149.3.9 MultiGBASE-T1-A operations, administration, and maintenance (OAM)

[Note for editor: Ignore headers/footers. Section numbering is incorrect due to starting from Clause 149, so everything in this document under “149.3.9” should replace 192.3.7. That is everything except PCS goes into 192.3.7. Cross references updated with editorial license as the current cross references to clause 149 in most cases become clause 192. Without EEE there is no use for the RS-FEC(16,14) described in clause 149 so that is removed in clause 192]

MultiGBASE-A operations, administration, and maintenance (OAM) is a subset of OAM as specified for MultiGBASE-T1

Figure 149–25—Transmit state diagram

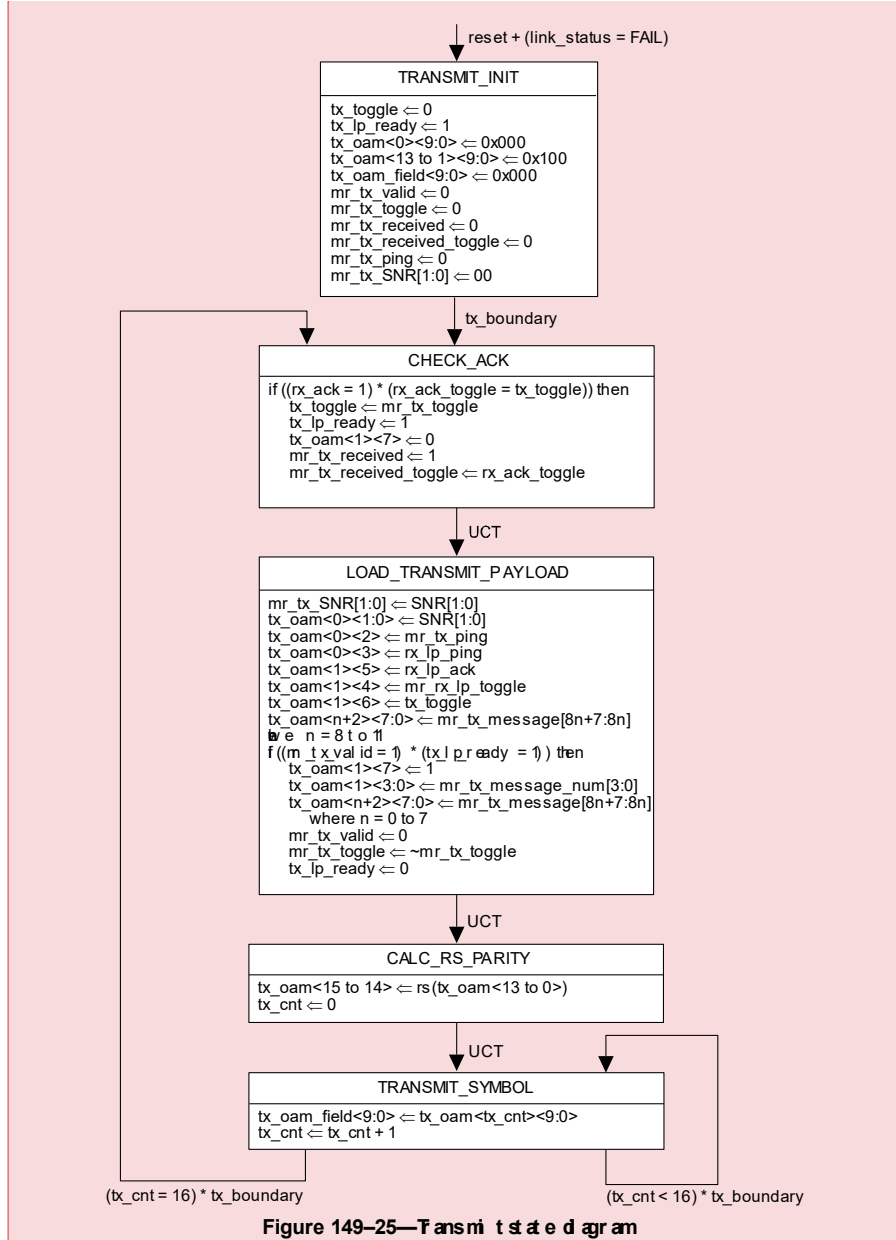
Commented [SM2]: Change CALC_RS_PARITY to INIT_TRANSMIT
Change “rs(tx_oam<13 to 0>” to 0x000000

[EDIT NOTES: Change CALC_RS_PARITY to INIT_TRANSMIT, Change “rs(tx_oam<13 to 0>” to 0x000000]
